Westbard Sector Plan, Work Session #4

Westbard Sector Plan, Work Session #4

ATTACHMENT 1

ATTACHMENT 2 –REVISED GRAPHICS

Figure 3.1.1: Proposed Zoning Map – Westbard Avenue District

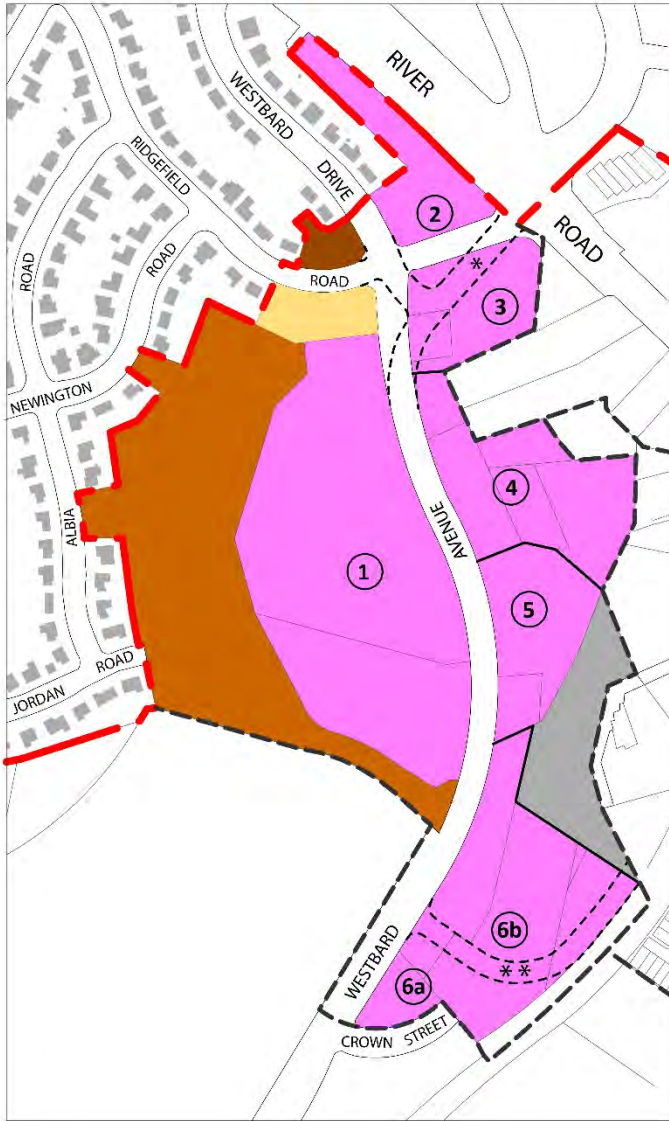
- Westbard Avenue District Site 2 (Figure 3.1.1 Proposed Zoning Map – Westbard Avenue District) parcel A, - the plan strongly encourages residential as the predominant use for this parcel. Commercial uses are strongly discouraged on this site.

- Westbard Avenue District Sites 6a and 6b (Figure 3.1.1 Proposed Zoning Map – Westbard Avenue District) parcels 466, 519, 510 and 576, - Heights of buildings to range between 35 feet at the south end of the site to 110 feet at the north end. Height transitions to be gradual, avoiding abrupt changes in height. The proposed connector street between Westbard Avenue and River Road to be located as far north as practical, and the heights south of this road to be a maximum of 35 feet. The height transitions to be detailed and illustrated more fully in the Westbard Sector Plan Design Guidelines.

- Westbard Avenue District Sites 6a and 6b (Figure 3.1.1 Proposed Zoning Map – Westbard Avenue District) parcels 466, 519, 510 and 576, - At the time of redevelopment, residential portions of the site greater than 35 feet in height must provide a minimum of 25% affordable housing units, including a minimum of 15% moderately priced dwelling units and 10% workforce housing units.

Figure 3.2.1: Proposed Zoning Map – River Road Corridor

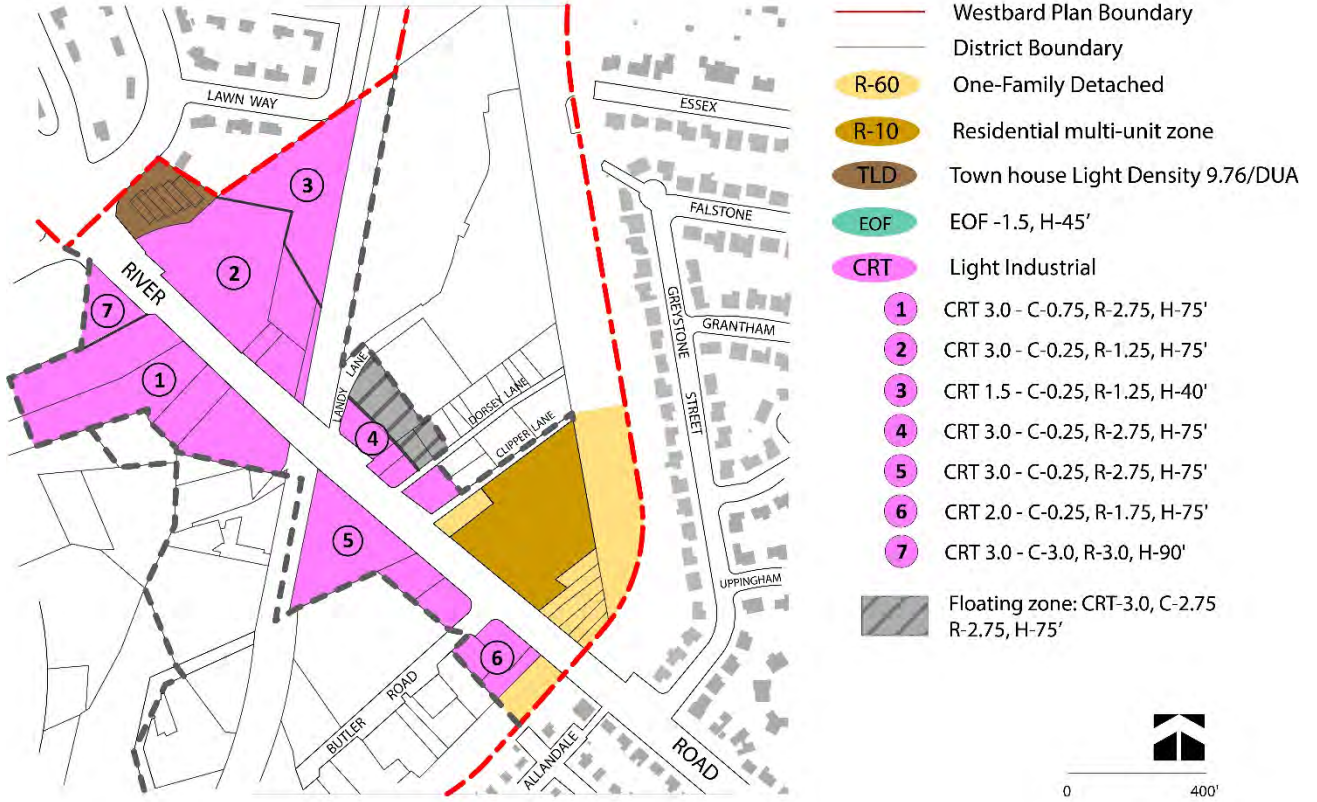
- River Road Corridor Site 2 (Figure 3.2.1 Proposed Zoning Map – River Road Corridor), parcels 029, 055, 082 and 109 - the proposed 75 feet of height, should only be allowed if future development includes the priority benefit incentive of a recommended green space along Willett Branch (See page 70: Community Open Space along Willett Branch). Future development should be placed closer to the Capital Crescent Trail, where feasible. This condition assumes assemblage of sites 2 and 3.
